To: INCITS Technical Committee T11
From: David L.Black, EMC Corporation
Email: black_david@emc.com
Date: June 6, 2010
Subject: FC-BB-6: ASFC for the FC pseudowire

Overview:

Proposed Changes:

Figure X – FC-BB_PW error indication control frame format

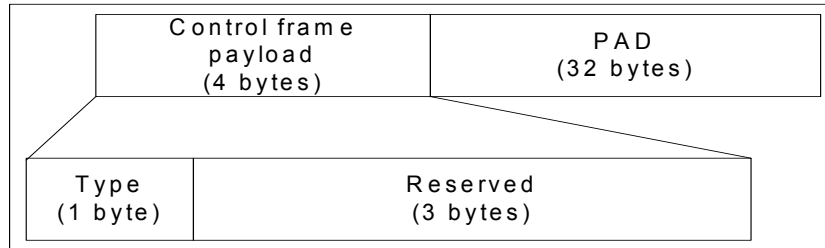
6.4.7.3 FC-BB_PW Alternate Simple Flow Control (ASFC)

ASFC defines two control frames, ASFC_PAUSE and ASFC_RESUME (see XXX), that may be sent by one FC-BB_PW device to a remote FC-BB_PW device.

Figure X specifies the control frame formats for ASFC_PAUSE and ASFC_RESUME..

An FC-BB_PW device sends ASFC_PAUSE to a remote FC-BB_PW device to direct that device to cease forwarding FC frames and FC Primitive Signals. Reception of a single ASFC_PAUSE control frame suffices to trigger such cessation, which shall take effect:

Editor's Note: Change 25 microseconds to something larger? FC-BB_PW devices have considerably more functionality and buffering than FC-BB_GFPT devices. 1 millisecond should be more than adequate, and may allow item b) above to be deleted, although keeping it does not cause any harm.

Table Y specifies the control frame payloads for ASFC_PAUSE and ASFC_RESUME.

<u>Field</u>	<u>Value</u>	<u>Description</u>
<u>Type</u>	<u>0x41</u> <u>0x42</u>	<u>ASFC_PAUSE</u> <u>ASFC_RESUME</u>
<u>PAD</u>	<u>Zeroes</u>	<u>Set to all zeroes.</u>

When FC frame and FC Primitive Signal forwarding has been suspended due to reception of an ASFC_PAUSE control frame, it shall remain suspended until at least one ASFC_RESUME control frame has been received. FC-BB_PW devices may send ASFC_PAUSE and ASFC_RESUME control frames at times, in numbers, and at frequencies at the discretion of the sending FC-BB_PW device.

Figure 24 – FC-BB_PW error indication control frame format

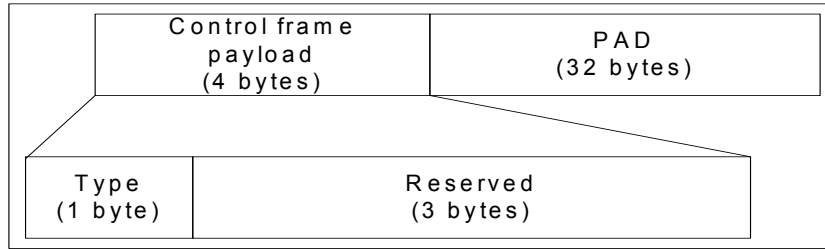
Editor's Note: Next change is in 6.4.8.2.2

This standard specifies the use of Type field values 0x81 and 0x82 for transmission of FC-BB_PW PING and PING_ACK (see 6.4.7.4.3) [and specifies the use of Type field values 0x41 and 0x42 for ASFC_PAUSE and ASFC_RESUME \(see 6.4.7.3\).](#)
